UNITED STATES PATENT AND TRADEMARK OFFICE

APPLICATION NO.	FILING DATE	FIRST NAMED INVENTOR	ATTORNEY DOCKET NO.	CONFIRMATION NO.
10/629,674	07/30/2003	Johannes Menzel	A 91755	6480

Office Action Summary	Application No. 10/629,674	Applicant(s) MENZEL ET AL.	
	Examiner Melody M. Burch	Art Unit 3683

DETAILED ACTION

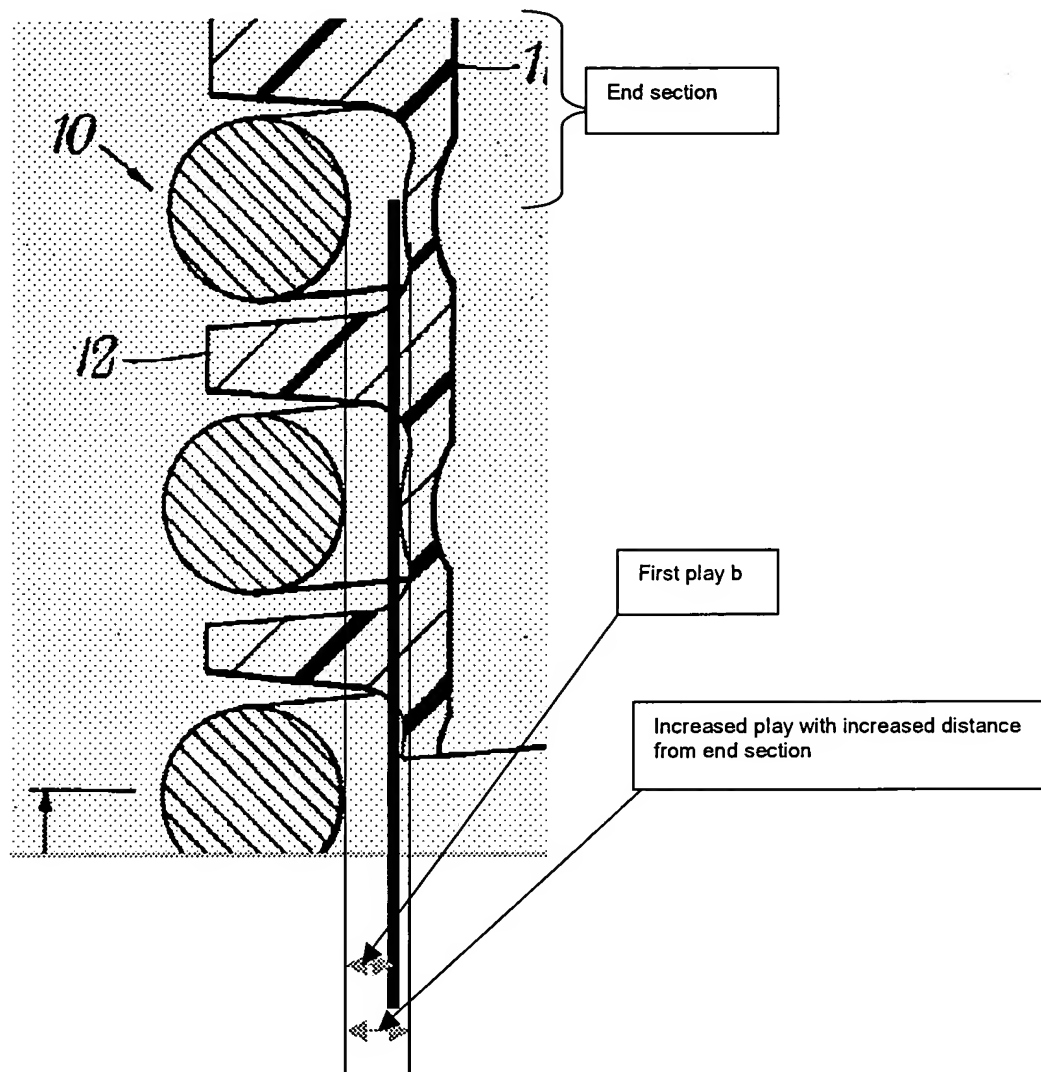
Re: claims 3, 20, 21, and 22. Clarke et al. show in the figure an antivibration element comprising: a coil spring 10 subject to deformation under load during operation of the antivibration element, the coil spring defining a longitudinal axis and having an end section, a midsection, and a transition section extending from the end section to the remainder, a guide member 12 having a helically shaped guide slot wherein turns of the coil spring are guided, the end section and the transition section being guided in the guide slot, the end section being fixed in the guide slot, the helically shaped guide slot

having a base and the transition section being guided in the guide slot with a first play to the base measured in radial direction as shown, the guide slot having first and second flanks delimiting the slot in the axial direction of the longitudinal axis, and the transition section having a second play to the first flank in the axial direction and a third play to the second flank also in the axial direction as shown with the plays becoming overcome during the deformation under load so as to permit the turns of the transition section to lie at least in part against the guide slot thereby increasing the stiffness of the coil spring.

Re: claims 6 and 7. Clarke et al. show in the figure the limitation wherein the coil spring has first and second ends (radial ends – one radial end shown at the radially outermost section of the right top coil and the other radial end shown at the radially outermost section of the left bottom coil) twisted relative to each other by approximately a half turn.

Re: claim 12. Clarke et al., as modified, show in the figure of Clarke et al. the spacing of the base of the guide slots to the longitudinal center axis becoming less with increasing distance from the end section from the bulge of the base down to the tapered portion of the base.
